## SUBDIVISION REVIEW SHEET

<u>CASE NO.</u>: C8-2016-0079.0A <u>P.C. DATE</u>: April 11, 2017

**SUBDIVISION NAME:** Resubdivision of a portion of Lot 8 Block A, Eastover

SUBJECT: C8-2016-0079.0A Resubdivision of a portion of Lot 8 Block A, Eastover

PROJECT: RESUBDIVISION OF LOT 8 BLOCK A

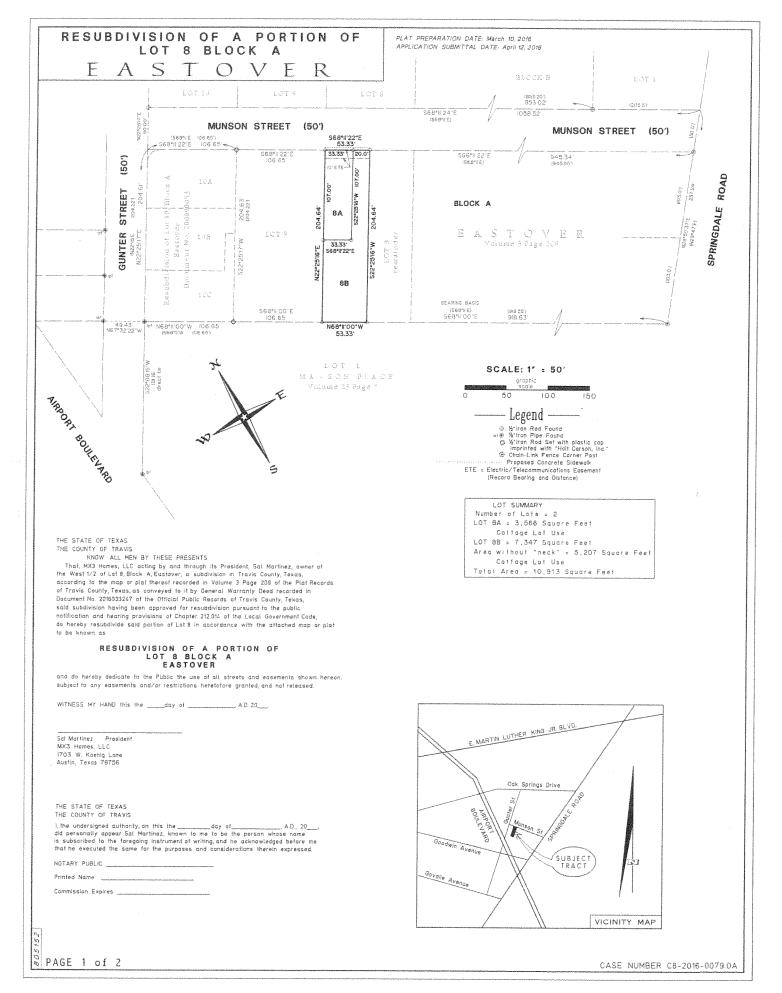
**<u>DEPARTMENT COMMENTS</u>**: The request is for the approval of the Resubdivision of a portion of Lot 8 Block A, Eastover subdivision composed of two lots on 0.25 acres. The applicant is proposing to resubdivide a portion of an existing lot into a two lot subdivision for residential uses.

**STAFF RECOMMENDATION:** If the variance is approved, the staff recommends approval of the plat. With variance approval, this plat would meet all applicable State and City of Austin LDC requirements.

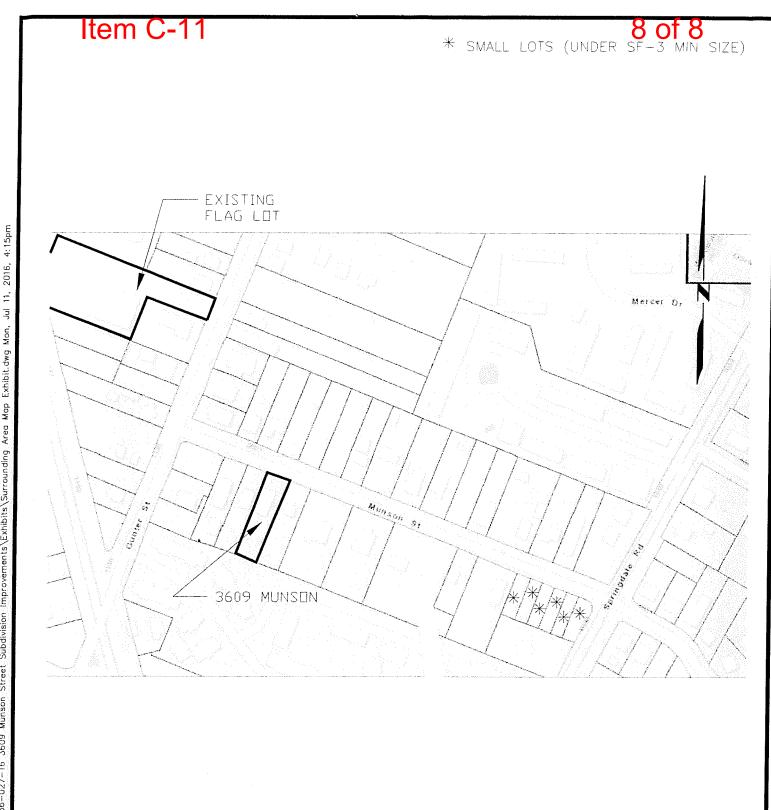
- (i) The site provides accessibility for emergency responders via Pennsylvania Ave and an increase in emergency vehicle access distance approved for Lot 2 per exception 3 to section 503.1 of the City of Austin fire code in effect on September 16, 2013.
- (ii) The site has adequate room for required utilities as demonstrated on the attached Driveway and Utility Exhibit.
- (iii) The site enhances environmental and tree protection by minimizing the impacts to existing trees, including not removing protected trees.
- (iv) The site is compatible with the surrounding neighborhood as demonstrated on the attached Surrounding Area Map.
